DELAURENTIS - VACANT LOT - 21 NETHERMONT AVE
NEW HOUSE CONSTRUCTION - TAX ID: SECTION 122.16-BLOCK 4- LOT 41

Re: 21 Nethermont Ave - Section, Block & Lot: 122.16/4/41 – Response to Comments Dated 03/18/2021

Below are responses to the questions/comments from 03/18/2021:

EXISTING CONDITIONS,
 TOPOGRAPHICAL SURVEY,
 TREE REMOVALS

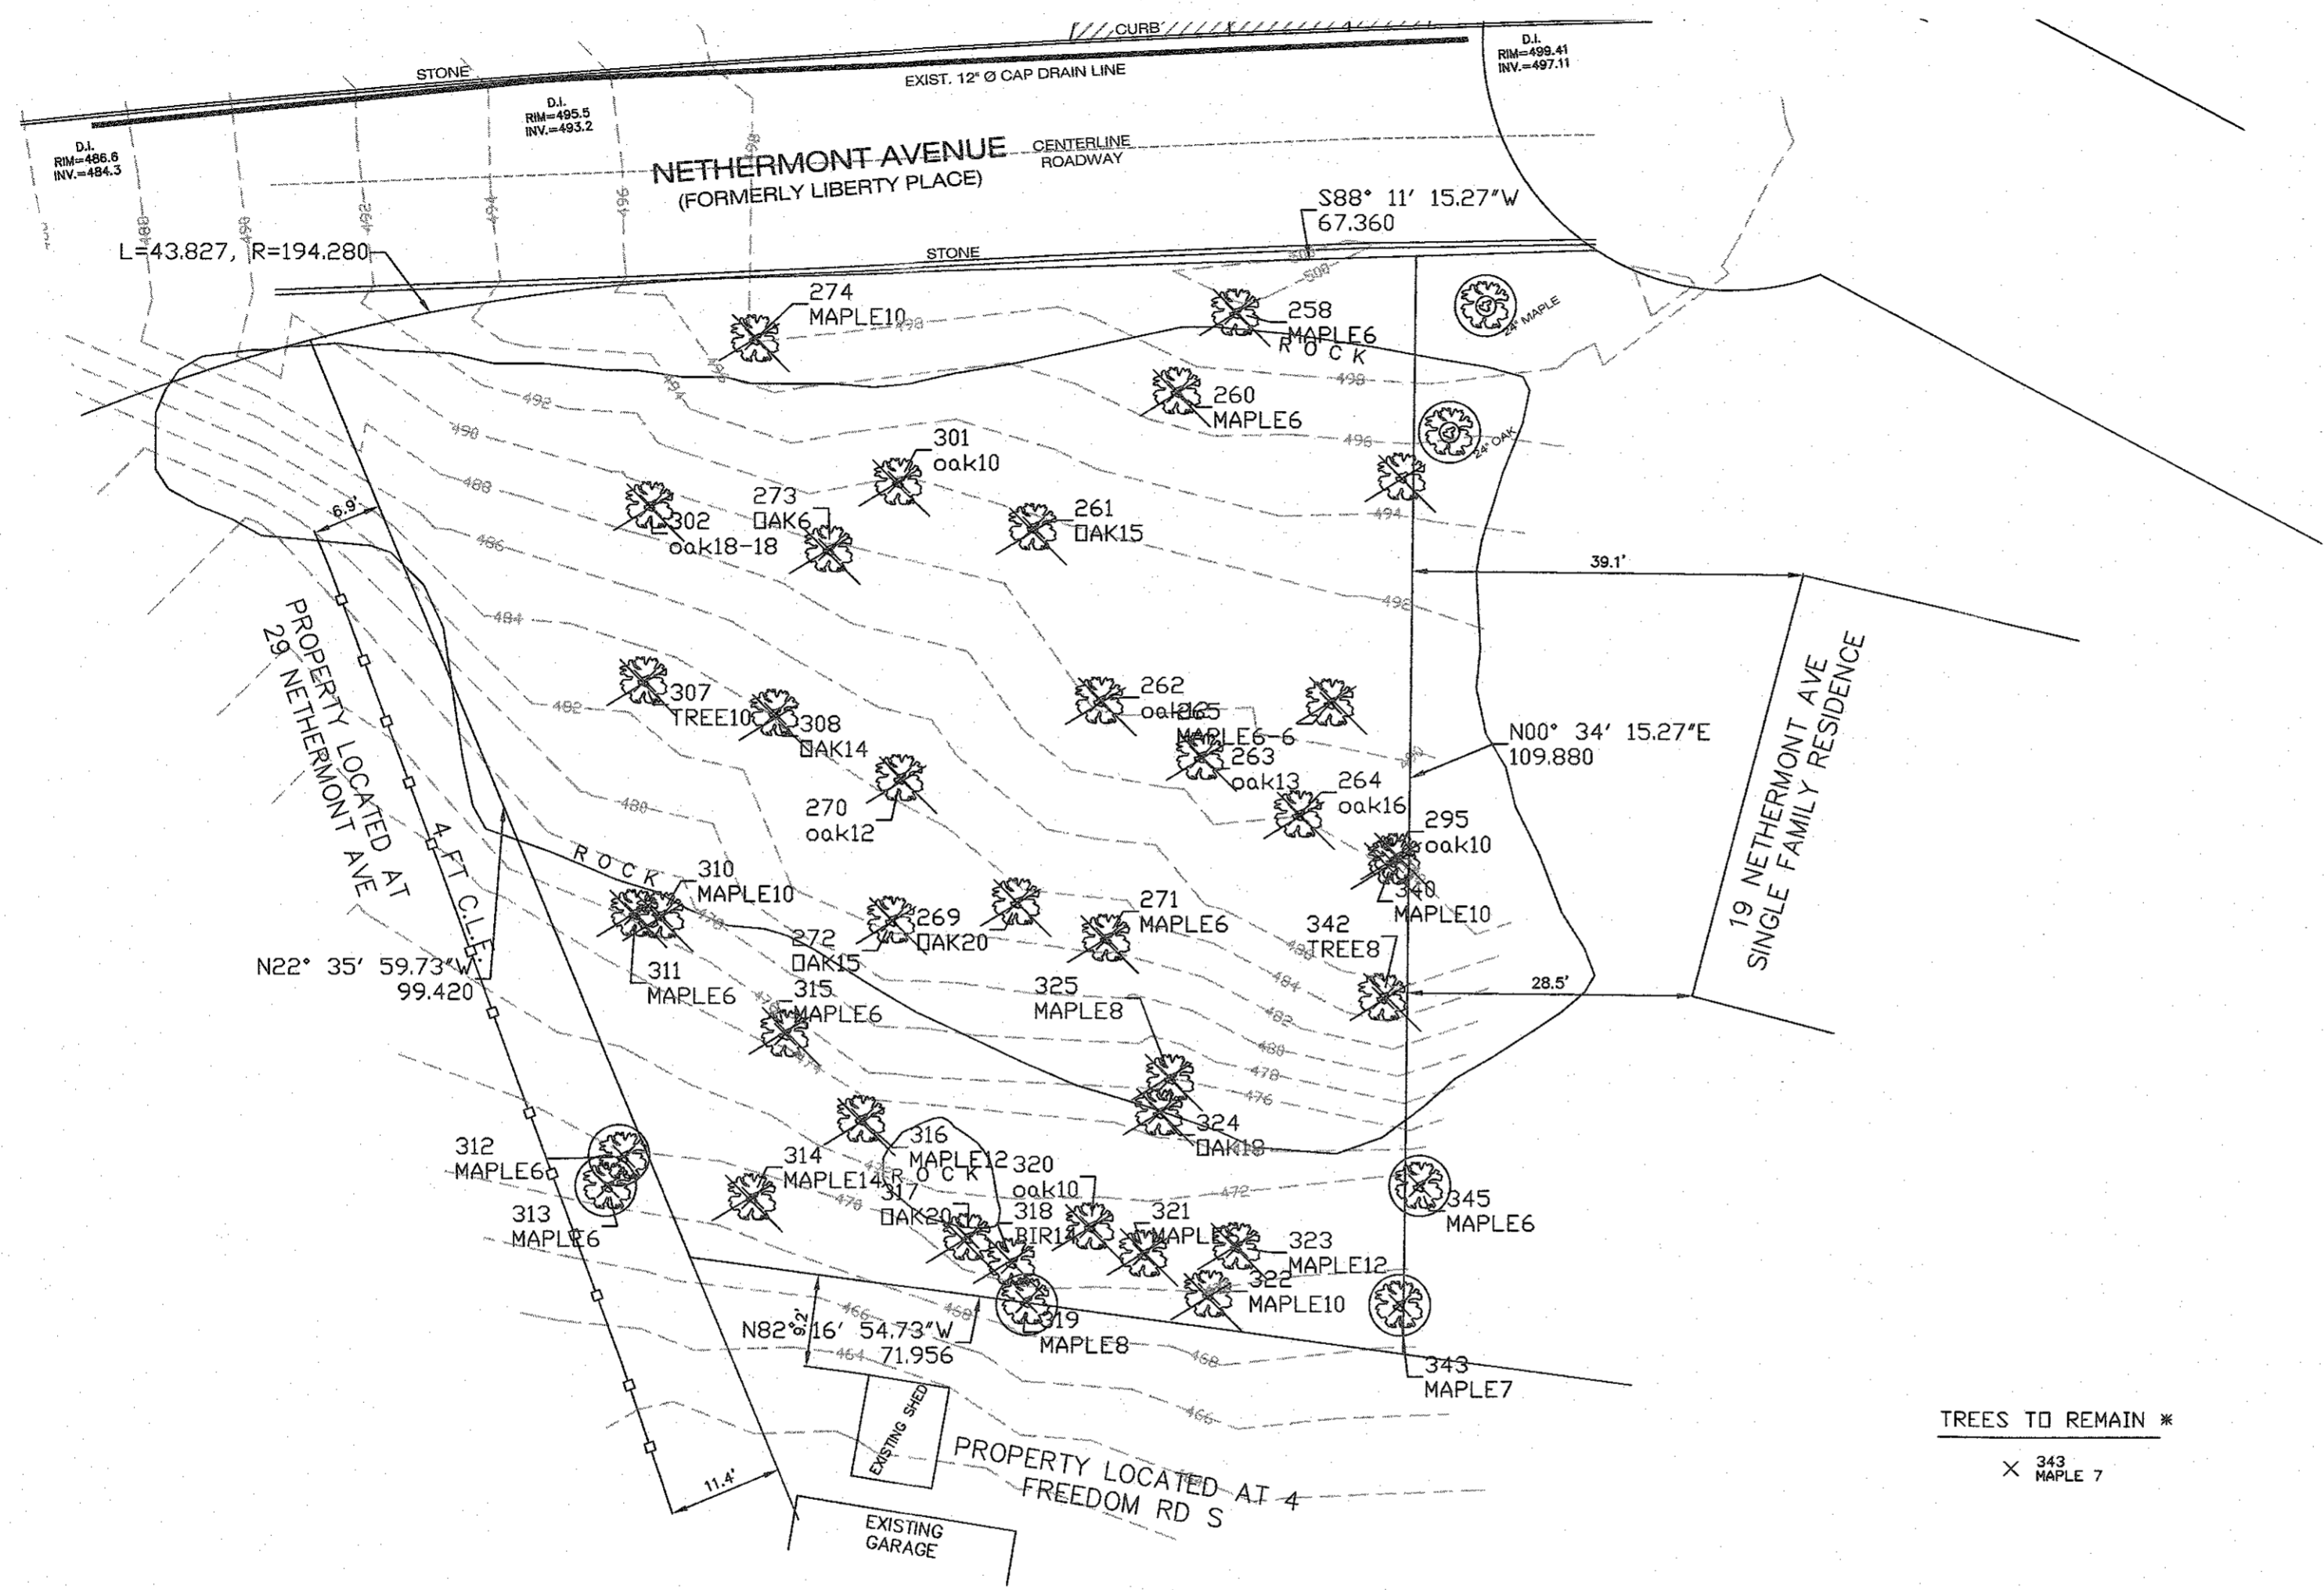
- A final landscape plan will be provided once a final design concept is accepted.
- 11. As previously requested, the Tree Removal and Protection Plan and Summary Table shall be revised to include only trees on the subject property.

- Tree removal and protection plan revised.
- 12. As previously requested, the driveway platform width should be increased to a minimum of 25 feet for adequate maneuverability out of the garage.

EXISTING CONDITIONS, TOPOGRAPHICAL SURVEY & STEEP SLOPE ANALYSIS

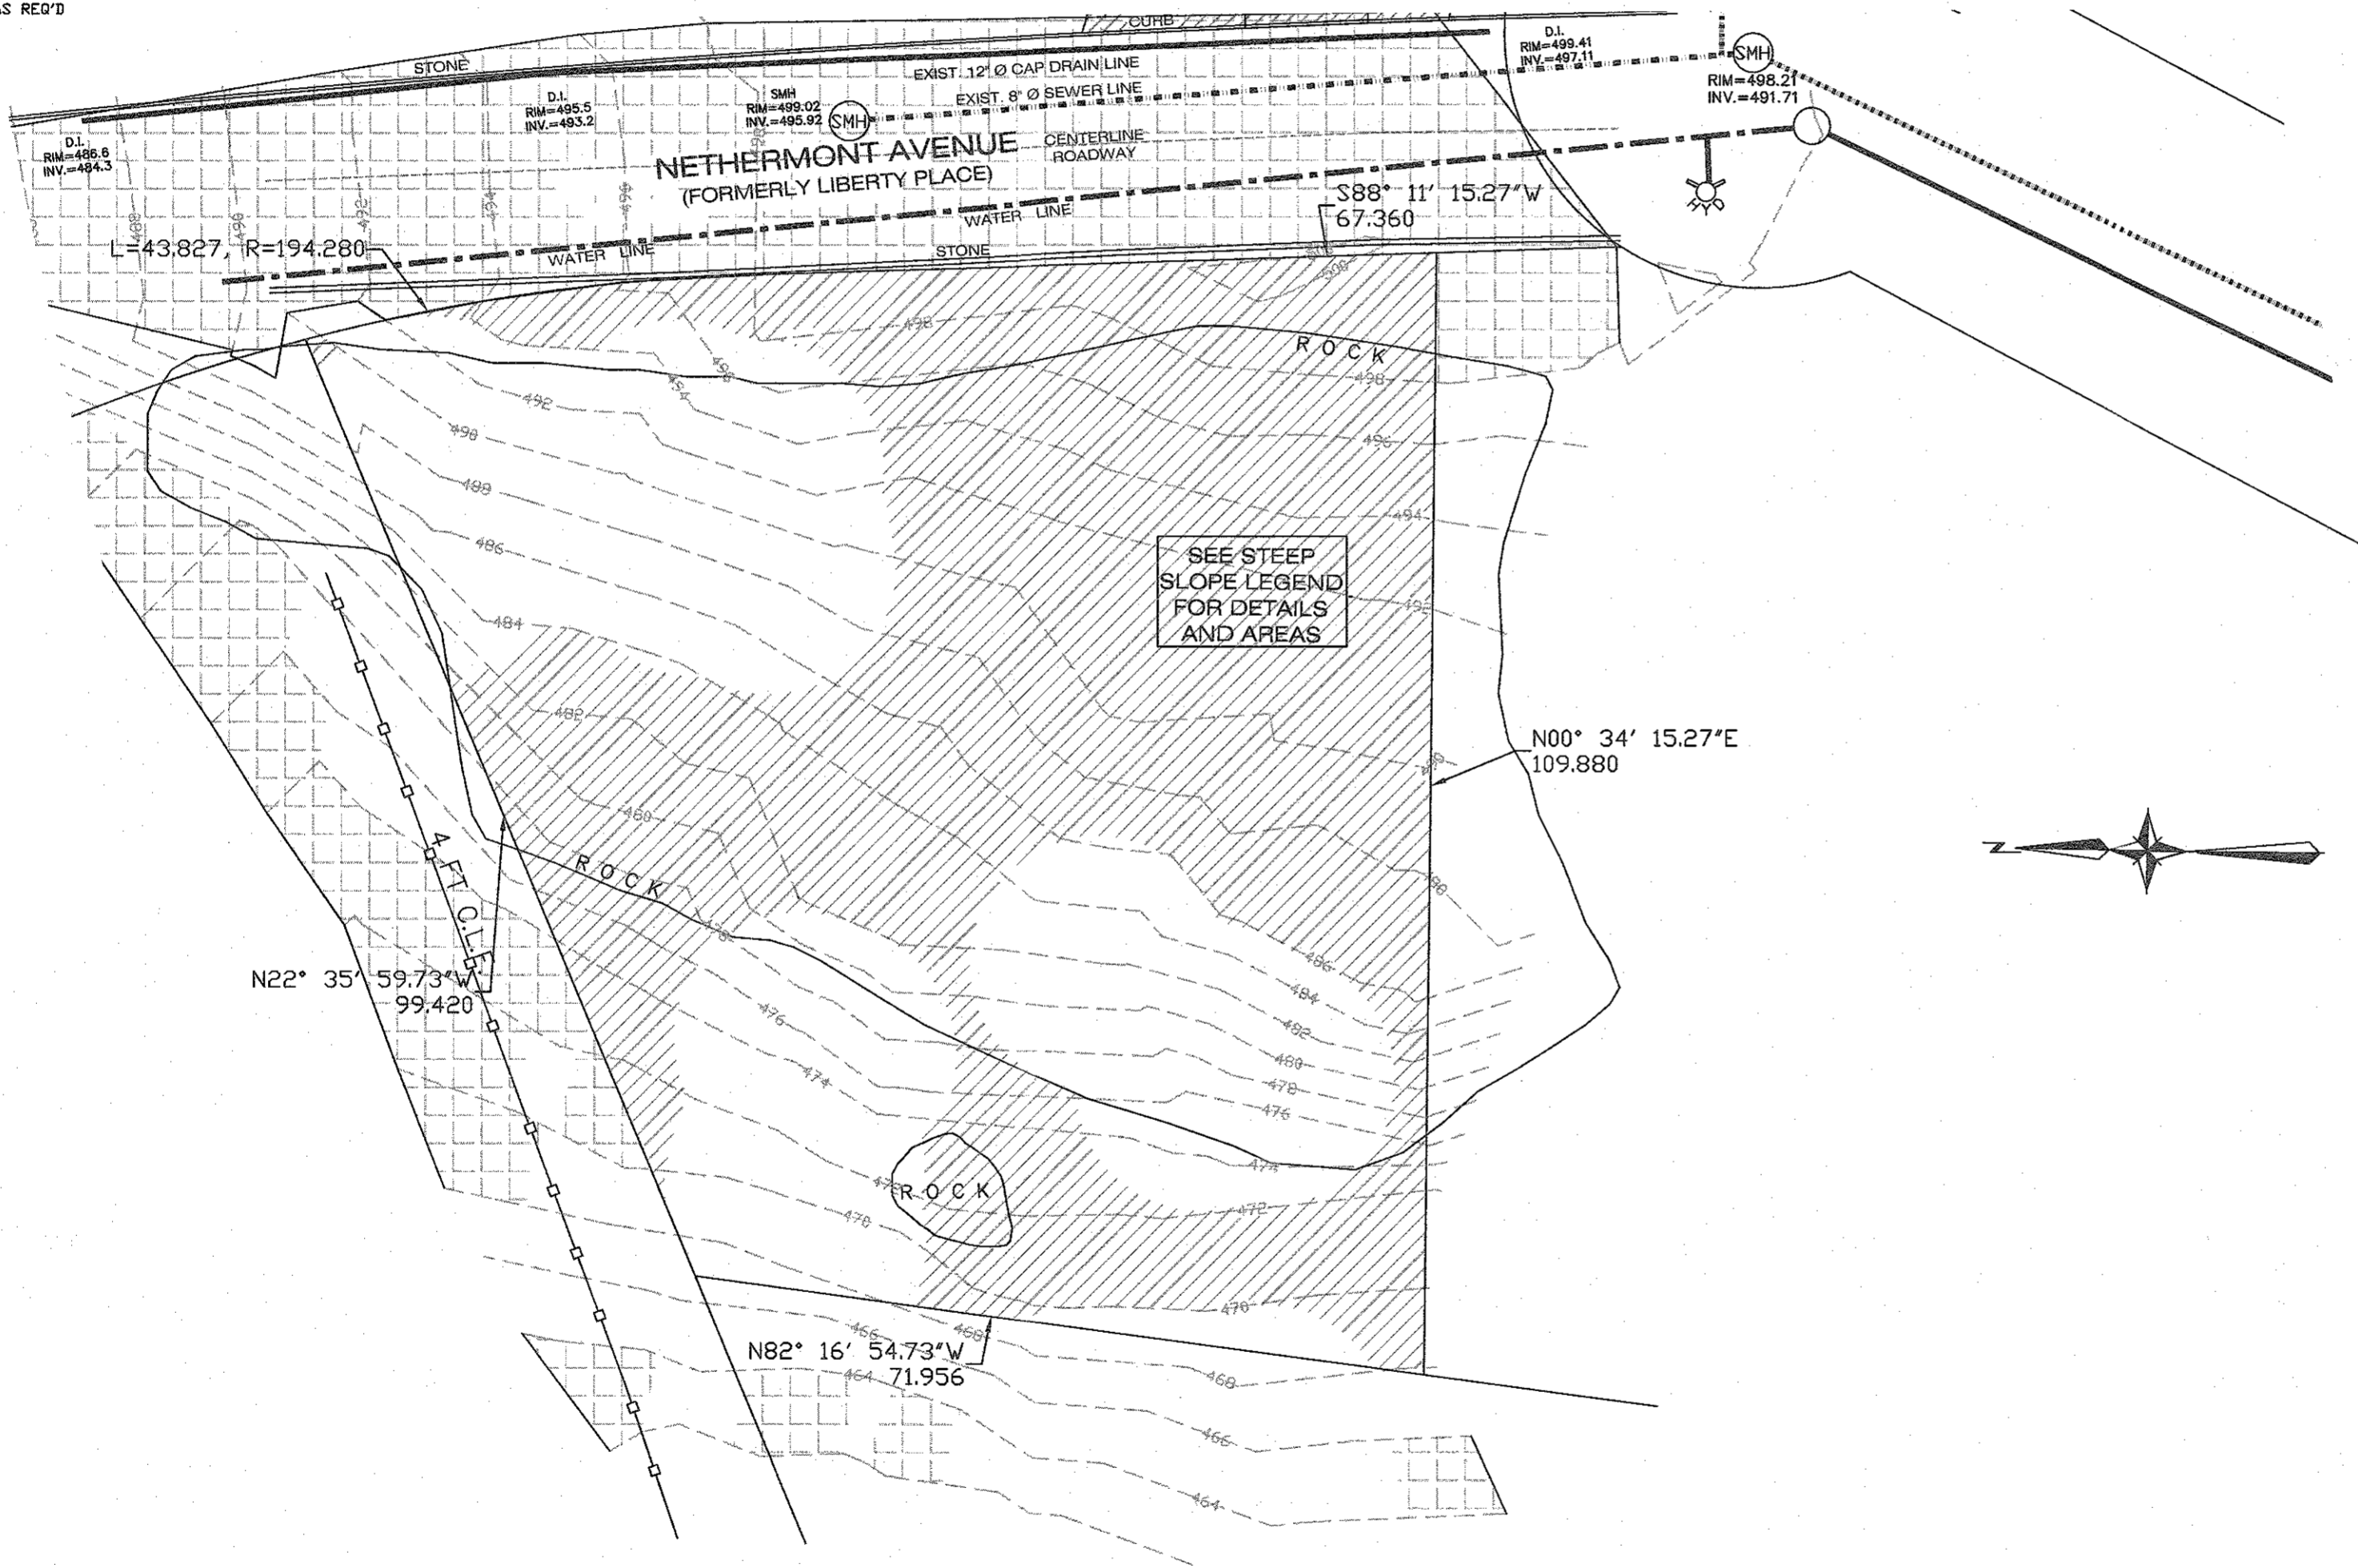
- **More detail will be provided once a final design concept is accepted.**
5. As previously requested, the net lot area calculations shall be removed from Sheet TS-1 "Existing Conditions, Topographic Survey & Steep Slope Analysis", since that is only applicable to subdivisions.

- **Calculations removed**
6. The applicant shall demonstrate zoning compliance with respect to building height. As defined by Town Code, the average grade used to determine building height in cases where the finished groundlevel slopes away from the exterior walls, as this does, the average grade shall be the lowest point within six (6) feet from the perimeter of the building. The applicant has provided average grade calculations; however, it appears that the elevations were taken immediately adjacent to the building. The calculation and supporting data should be revised accordingly and verified by the Building Inspector.

SCALE: 1" = 20'
 DATE: DECEMBER 11, 2020
 DRAWN BY: GC
 CHECKED BY: ES.
 FS - 1
 SHEET 6 of 6

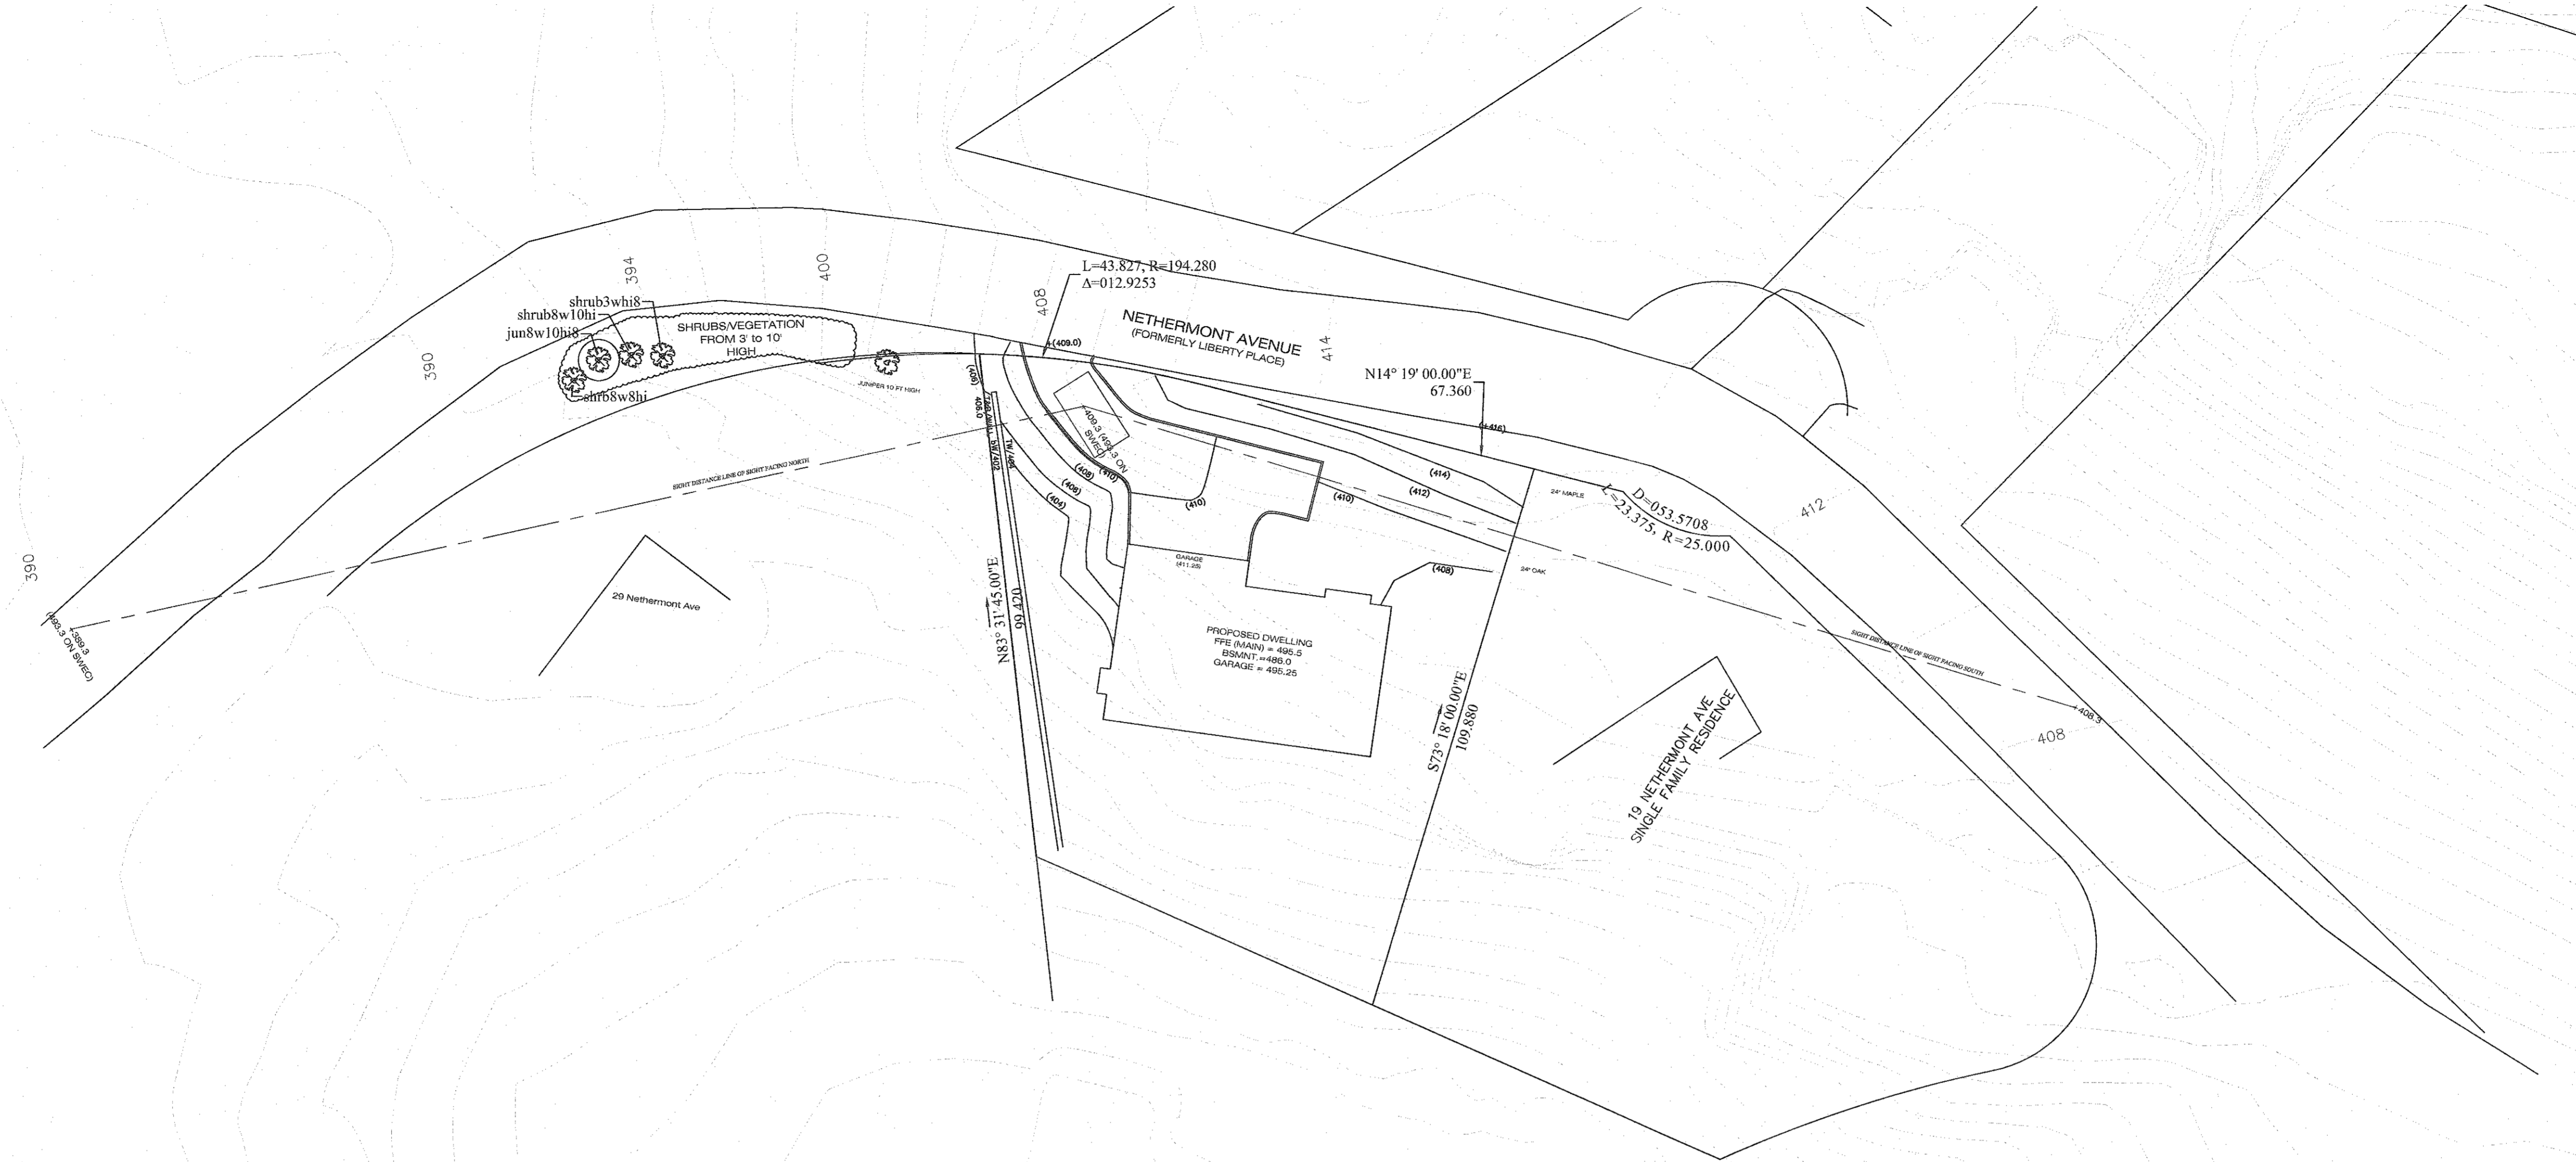
- **Retaining walls revised and fill quantities significantly reduced.**
2. As previously requested, notes shall be added to the “Fill Delivery and Material Staging Plan” specifying compaction requirements and the fill material specifications.

- **Compaction specifications and notes added to “Delivery and Material Staging “ plan sheet.**
3. As previously noted, the plan proposes tiered six (6) foot high retaining walls in the rear of the property, in close proximity to the property line. The Board should review the retaining wall layout and consider whether they are aesthetically pleasing and compatible with the surrounding residential character. Additional screening or other mitigation may be recommended. The Board may wish to consider reducing the height of the tiered walls or adding a third tier (three – 4 foot walls as opposed to two – 6 foot walls). The applicant should provide cross sections at appropriate locations through the site, front to back and left to right, for the Board’s understanding of how the proposed grading and retaining walls will relate to adjacent properties.
